312 W Hyman Ave_0014-2024-BRES_BuildingComment1_Markup Summary

90. Arch Sheets.pdf (18)

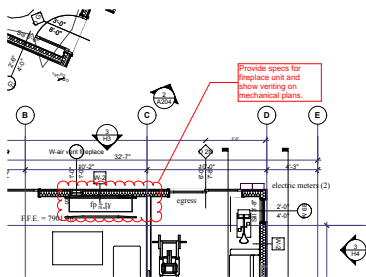
Snowmelt, provide or demonstrate:

-Detail showing minimum R-10 insulation underneath snowmelt.

-Completed REMP worksheet with snowmelt area and boiler efficiency entered.

-Ensure REMP worksheet and all drawings (architectural, mechanicals, landscape, etc) are coordinated. (REMP worksheet provided shows 25 sq. ft. of snowmelt. Plans show 36 sq. ft.). Provide specs for electric snowmelt mat.

-Automatic controls configured for system shut off when surface temperature and air temperature are above 40°F and no precipitation is falling.

See A101 Architectural Site Plan
 * Plans show 6' x 6' = 36 sq. ft of snowmelt
 * REMP will match
 * Assembly F2 on Page A600 shows 2" Polyiso Rigid insul, R-13
 * Spec calls for Warmup WSMW Snowmelting Mats at entry
 * Spec calls for Melting Controller, sensor controled to activate the heating elements.

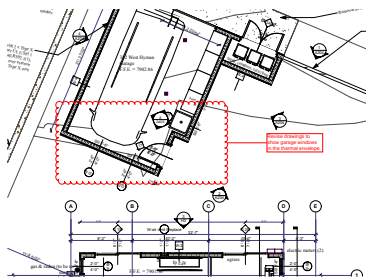
Provide specs for fireplace unit and show venting on mechanical plans.

See A103 Main Level. This is an electric fireplace. Expedited review as per AHJ. Vent was a placeholder for HPC and has been removed as no make-up air is needed. All electric remodel.

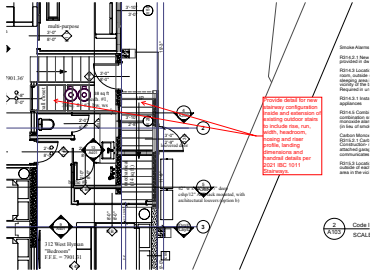
Is this door supposed to be here? Elevation shows a full height door, but the landing for the new stairs goes all the way to the wall in the middle of what is shown as a door and structural plans show infill for this existing door. Coordinate across plans so all show the same feature.

See A103 D1E. This residence was built in the 1950's. We have reversed the operation of the door. This is not the front door. This is no longer a city or private duplex. The main entry is on the West. This is a secondary access to mechanical. from the stair landing (interior), the door will not be visible from the interior stairs.

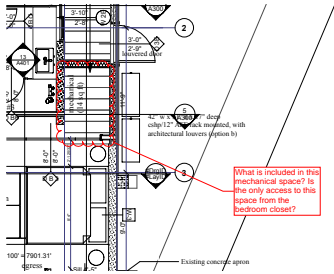
Provide detail for new stairway configuration inside and extension of existing outdoor stairs to include rise, run, width, headroom, nosing and riser profile, landing dimensions and handrail details per 2021 IBC 1011 Stairways.

See A111 Exterior Stairs Enlarged. The exterior stairs were built by the City of Aspen. Jeff Pendarvis, Capital Assets. 0112.2012.AGGR. there is no change to the rise or run, only a move of the existing treads to the North. See new sheet documenting the stairs as per currently adopted I-codes. As per the City of Aspen Capital Assets and HPC/Historic Modern programme.

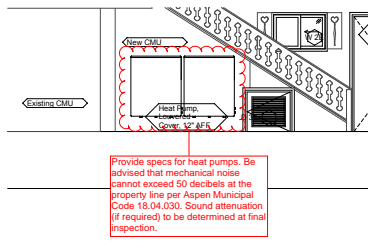
Provide detail for railing/guard per IBC 1015 Guards

See assemblies on A600 and A111 new stairways and railings/guards enlarged as per elevation: 36" high t&g railing/guard, as per 1015 Guards

1607.9.1.1 concentrated load of 200# as per struct

1607.9.1.2 guard and handrail and top rail designed to withstand 50# concentrated load.

36" to top of &g + 1"= for residence guard height exceeds 34" top- is wood to match t&g

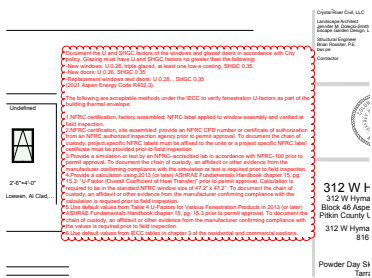
Per 2021 IBC 1031.2.1 Operational Constraints and Opening Control Devices, emergency escape and rescue openings shall be operational from inside the room without the use of keys or tools. These decorative "garage doors" must not have the ability to lock.

These are shutters as depicted. They do not lock. They are habitable spaces. The shutters are operable from the interior and exterior. The shutters are to be open when the habitable spaces are occupied.

The egress from the bedrooms includes two egress points

1) To the interior of the residence and 2) through the Loewen Glass/Aluminum doors (tempered as per schedule). Conforms with Section 1031. Egress to exterior, no locking HW in shutters.

The shutters do not lock, they are decorative shutters. As per contract with COA. In accordance with three HPC resolutions.
